Subject: FCC Class II Permission change for FCC ID: T7HR4027

Original Grant Date: 10/27/2019

This is to request a Class II permission change to our product name: DECT Repeater, IP DECT Repeater, Repeater, RFP14 Repeater; (FCC ID: T7HR4027), the device is identical to the previously certified except for the changes as below for details;

Layer	Previous Version	New Version
Top		
No change except PCB Antenna shape		
Inner 2	/	
additional ground plan

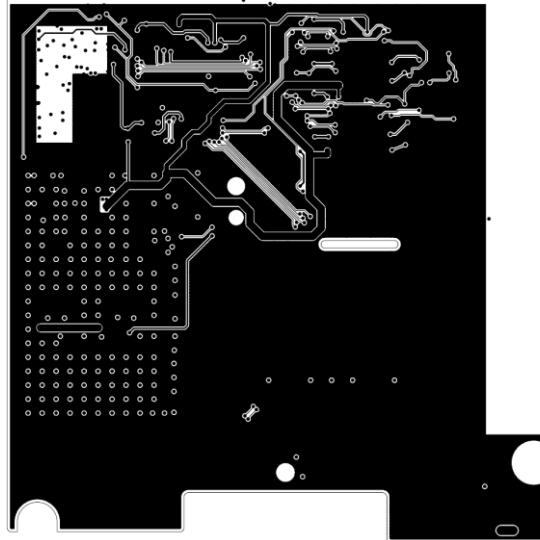
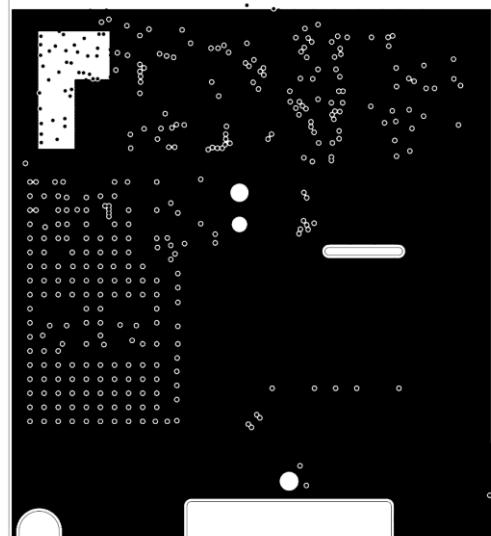
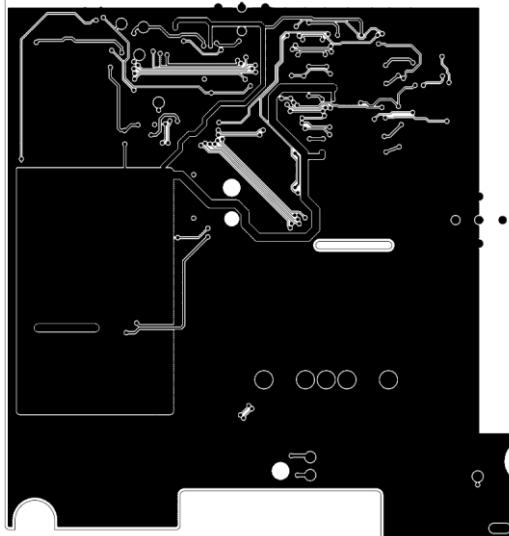
6) Change from 2-layer PCB to 4-layer PCB.

The change is to add extra ground plan by moving the bottom layer to Inner layer 3 and add ground plan on Inner layer 2 and bottom.

move bottom layer to Inner layer 3

additional ground plan
